<b>Attention:</b>	Kelly Van Marter, AICP Planning Director and Assistant Township Manager
<b>Subject:</b>	Family Farm and Home – Special Land Use and Site Plan Review #1
<b>Location:</b>	3685 East Grand River Avenue – north side of Grand River, west of S. Latson Road
<b>Zoning:</b>	RCD Regional Commercial District

**Re: Family Farm and Home Site Plan Review #1**

RE: Family Farm & Home-Special Land Use and Site Plan Review #1  
Dear Kelly,

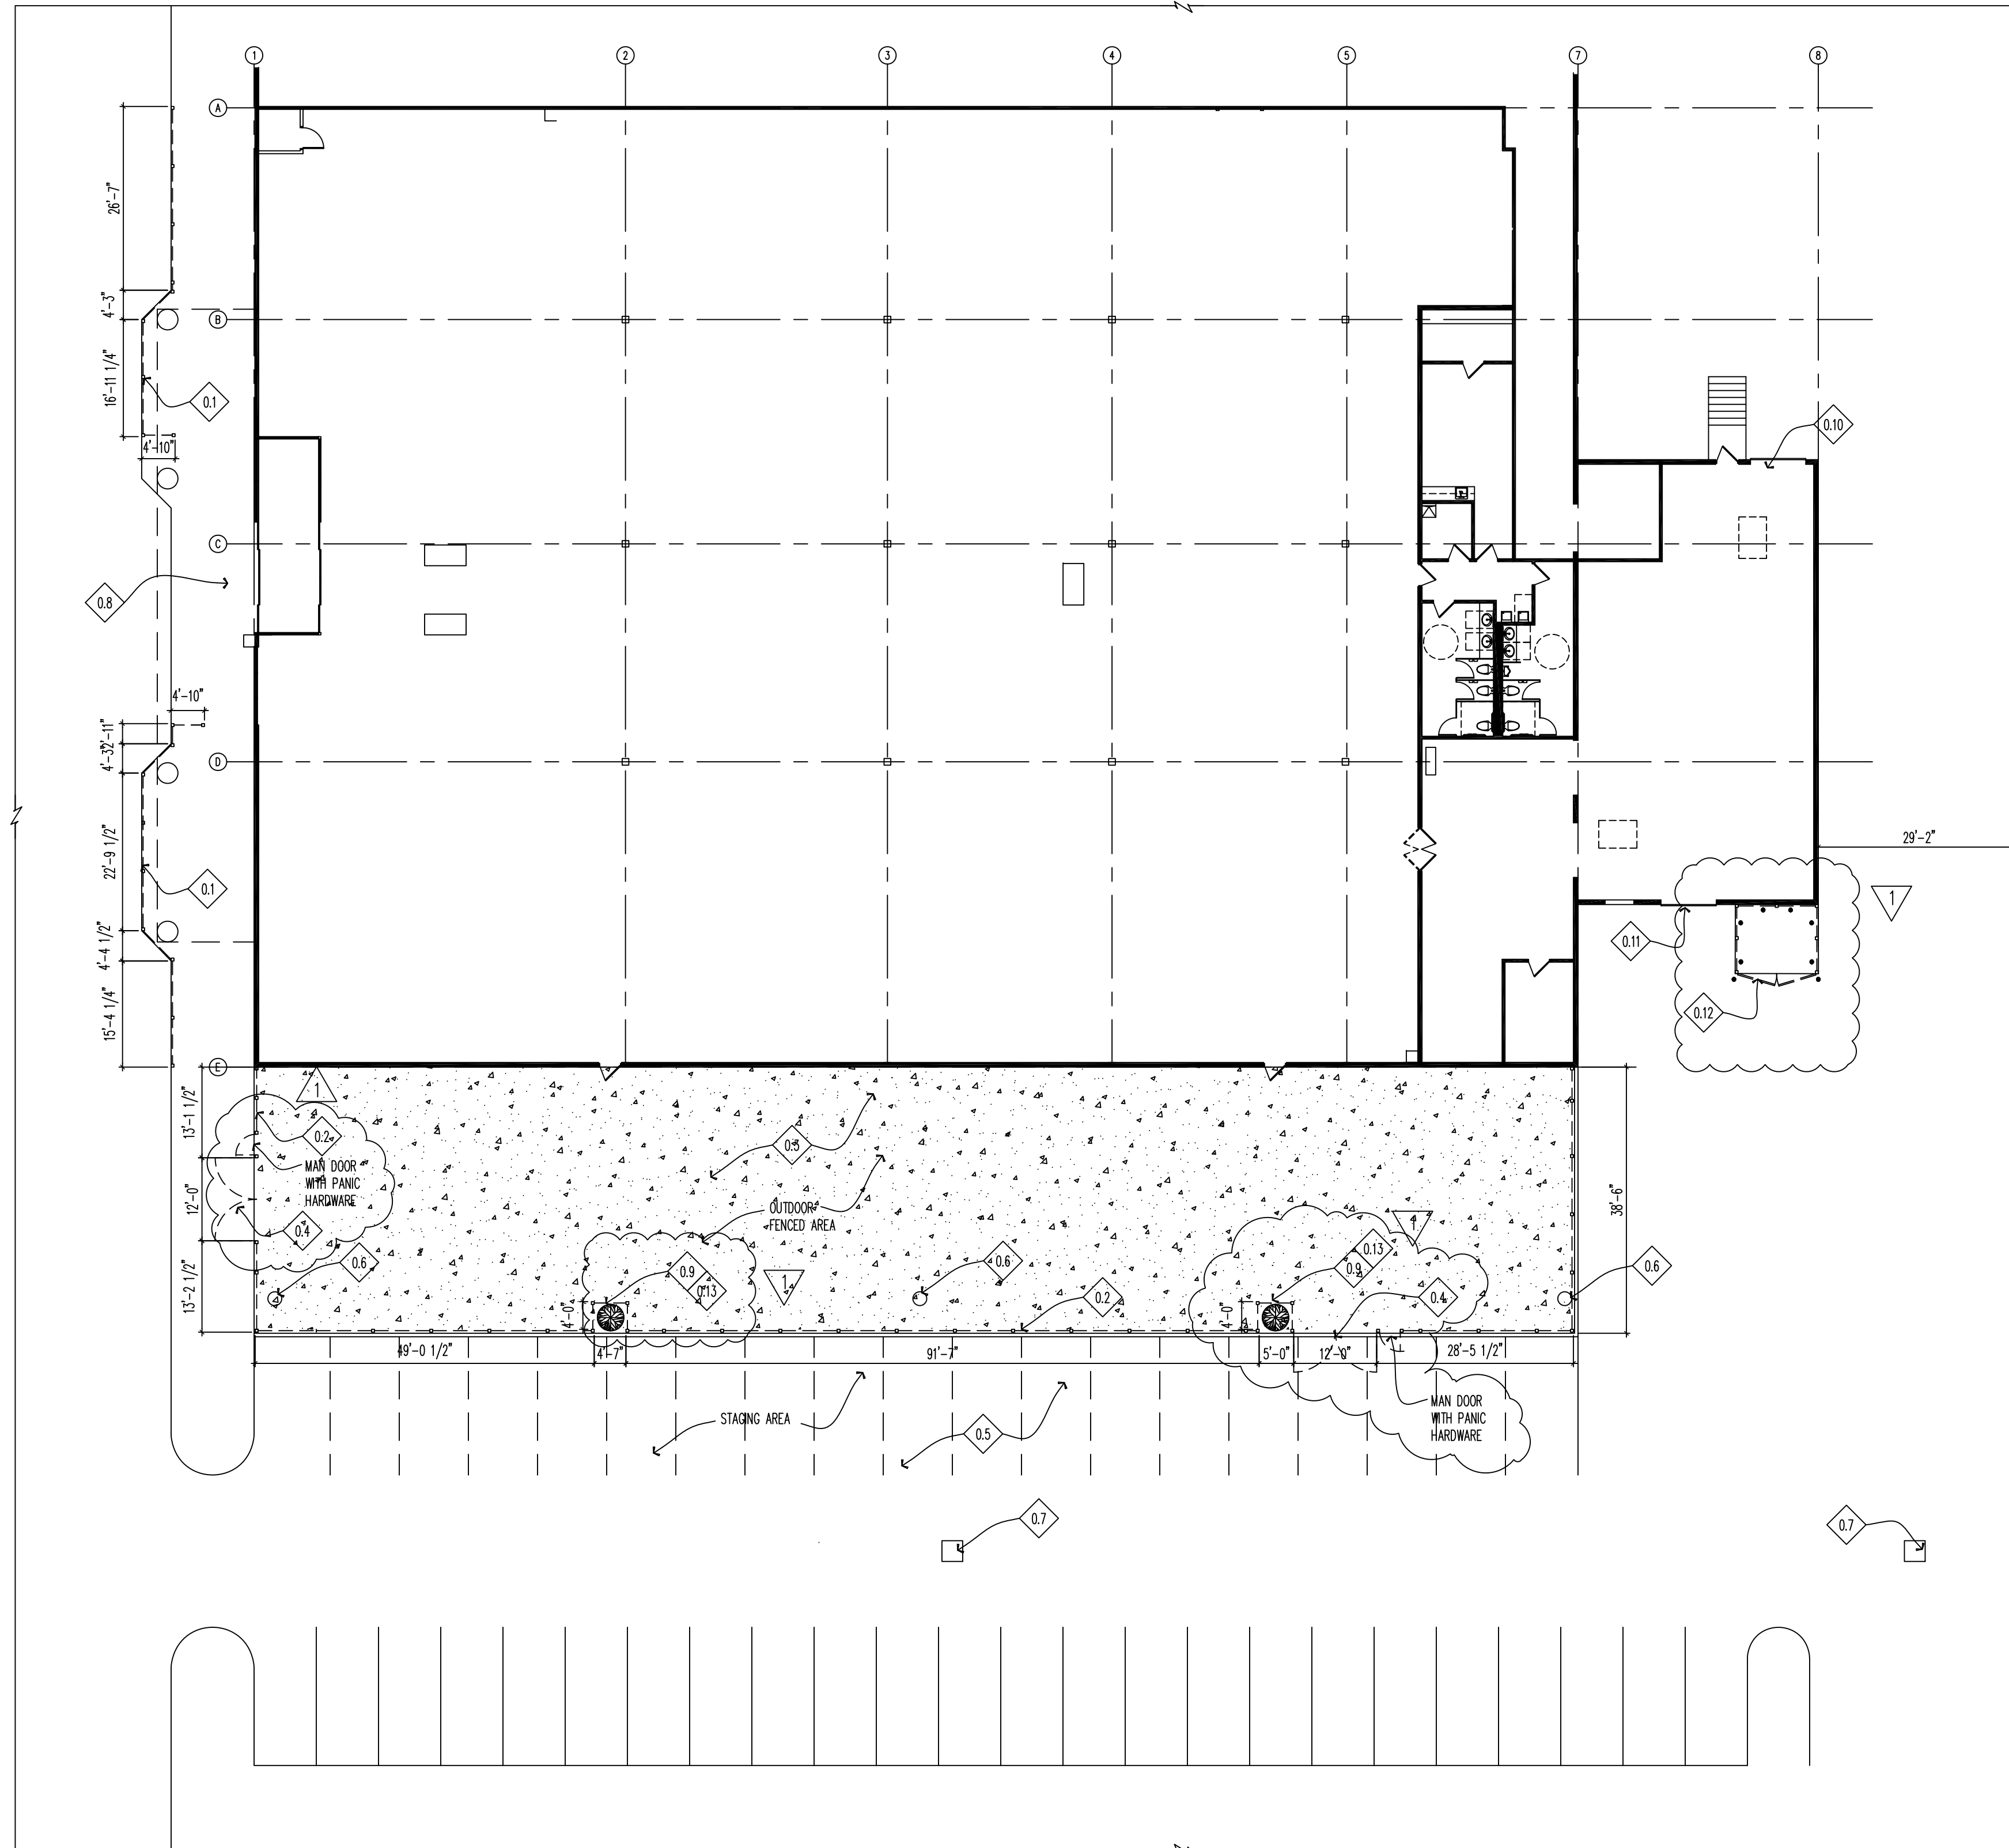
Section 7.03 requires setbacks of 50 (rear) and 20 feet (side). Provided the lines depicted on Sheet SP1.0 are the actual property lines, the proposed storage area provides setbacks of approximately 64 feet (east) and 54 feet (south).

This standard is met; however, we request the applicant clearly identify the lines shown as property lines. Furthermore, we request the applicant provide dimensions from these lines, as the plan is drawn at an architectural scale while site plans are required to be drawn at an engineering scale.

Furthermore, we request the applicant provide dimensions from these lines, as the plan is drawn at an architectural scale while site plans are required to be drawn at an engineering scale. **See revised plans from Alpine Engineering**

**A5.1**

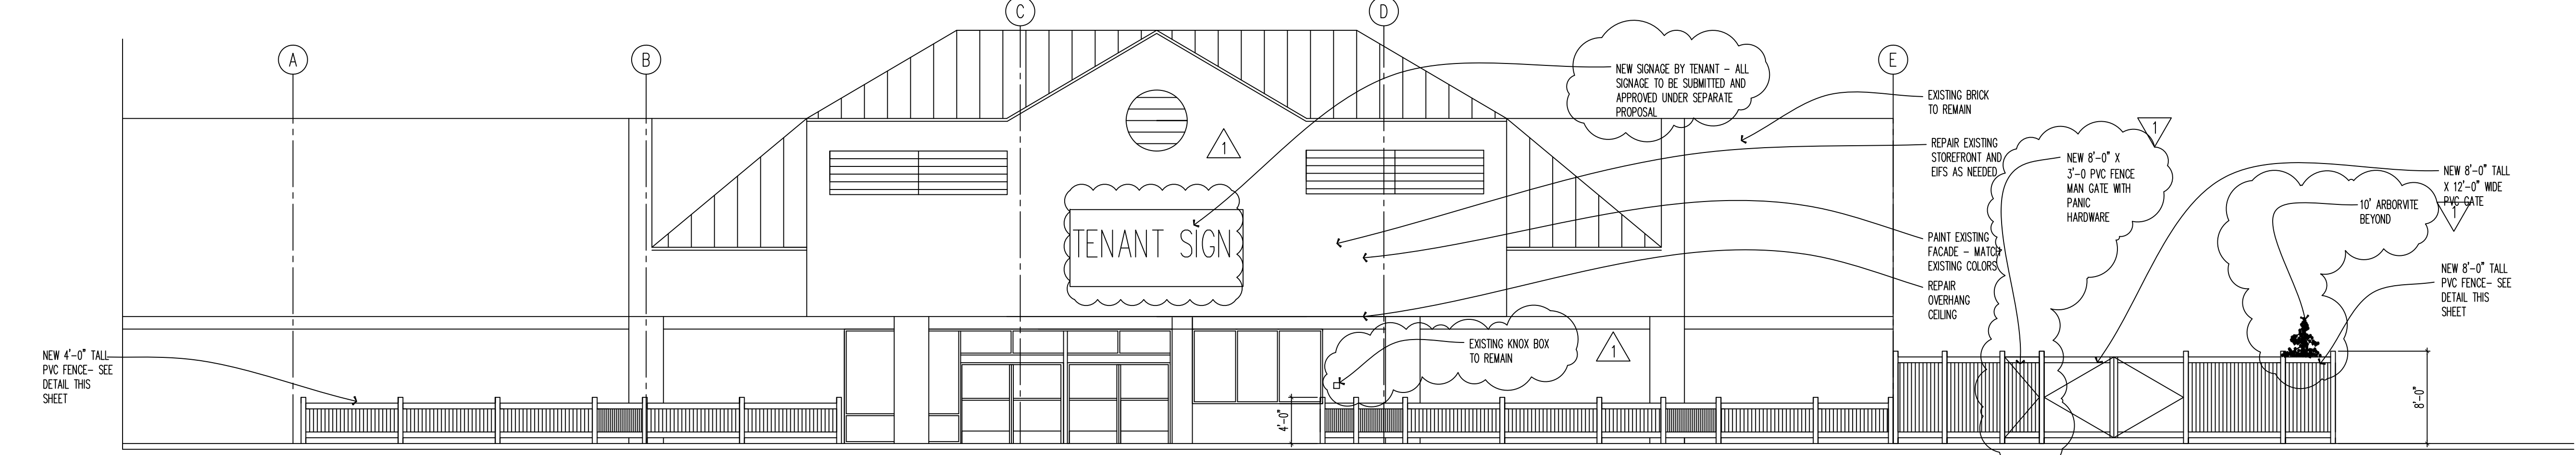
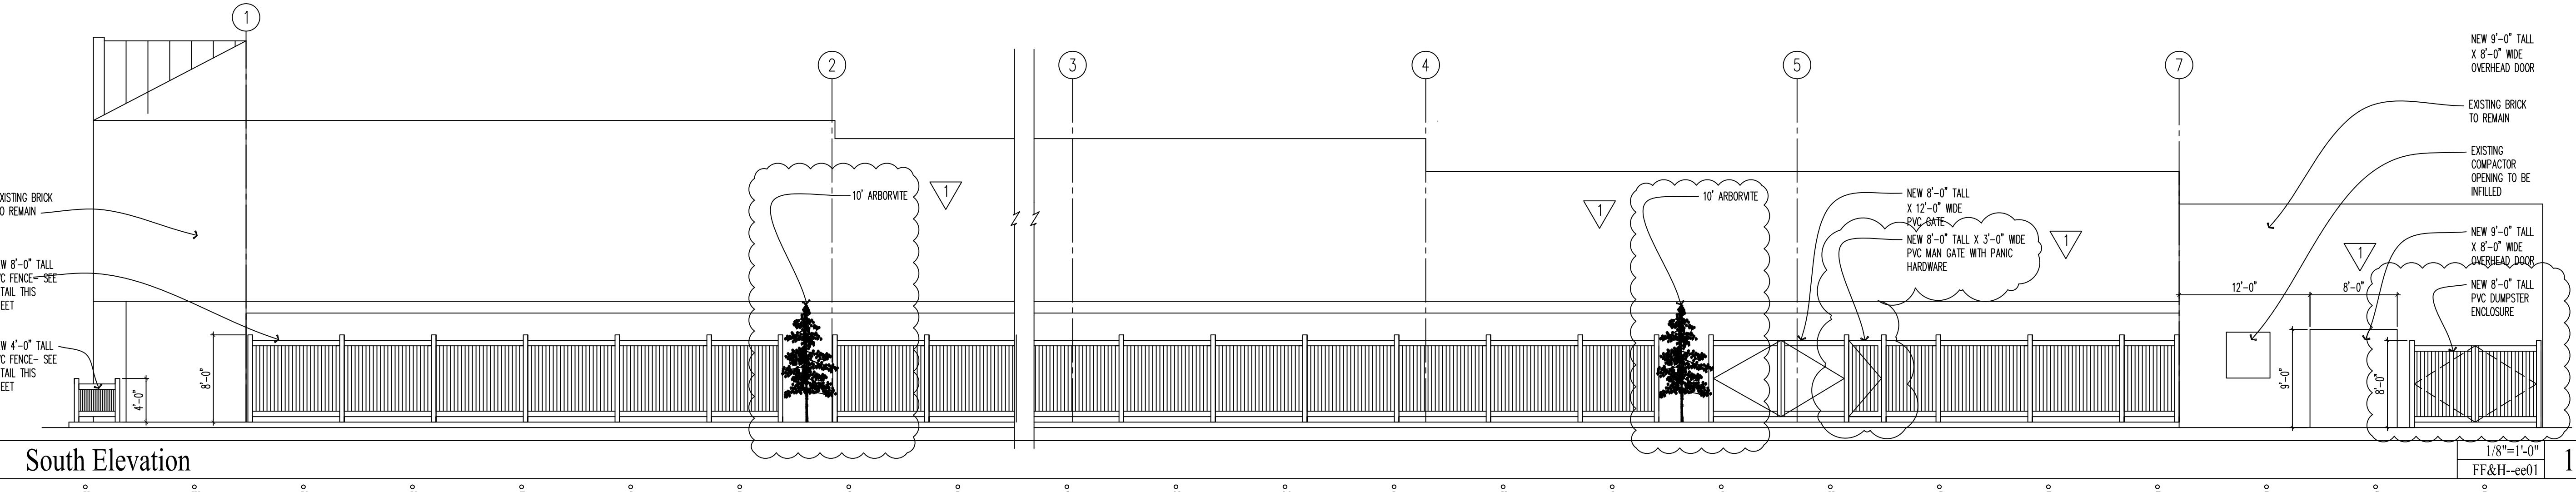
Additionally, the site plan (Sheet A5.1) notes an 8-foot tall fence, while the special land use application (response to item a) notes a 6-foot tall fence. The submittal must be corrected for consistency.

8. **Signs.** Sign details are not provided, although the building elevation drawing (Sheet A5.1) identifies an area for a new wall sign.

The applicant should be aware that the area depicted (approximately 208 SF) is much larger than that allowed by the Zoning Ordinance (100 SF). We request the applicant correct the drawing to avoid any future confusion.

10. The size of the wall sign depicted on Sheet A5.1 should be corrected to reflect Ordinance standards. **See revised plans from Metro Group Architects**

The applicant should be aware that the area depicted (approximately 208 SF) is much larger than that allowed by the Zoning Ordinance (100 SF). We request the applicant correct the drawing to avoid any future confusion. **See revised plans from Metro Group Architects**
